This interesting manuscript follows a relatively large scale experiment in which contaminated water (perchlorate) is pumped, and the shallow subsurface acts as a reactor for the remediation. The presented work include experimental work (some of it already presented, but its extent is not clear from the presentation), and a numerical model using the HYDRUS platform. Overall the manuscript is easy to follow, presents an interesting approach (even if somewhat questionable), and is of value. Most of the conclusions make sense. However, too many aspects need to be improved before the manuscript can be accepted for publication. Primarily, the authors need to convince that their model is reliable - I was not convinced and therefore I could not evaluate the model results and the conclusions drawn by these results

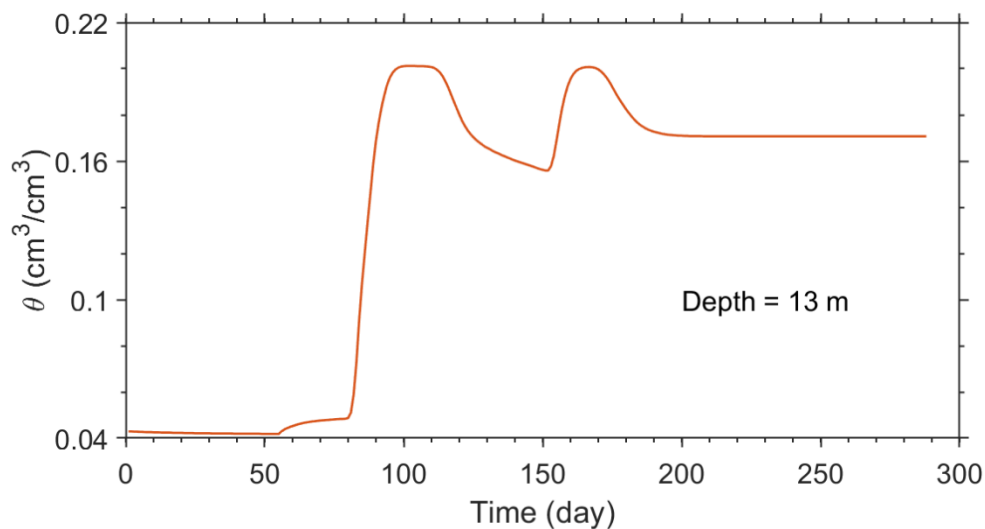
16. the use of a one-dimensional model should be justified. Clay layers tend to induce lateral flow

Reply to comment 16: no evidence for saturation in the clay layer was observed thus we don't expect lateral flow during the treatment. Moreover, we don't have any information to support a 3D model, and no significant benefit from such a model. Below we provide simulated water content at the at the bottom of layer 3, and close to layer 4 (the clay layer). The saturated water content (θ_s) of layer 3

and layer 4 are 0.37 and 0.38, respectively (Tables 1 and 2 in the manuscript). The simulation results illustrate that only unsaturated conditions prevail during the time of the experiment.
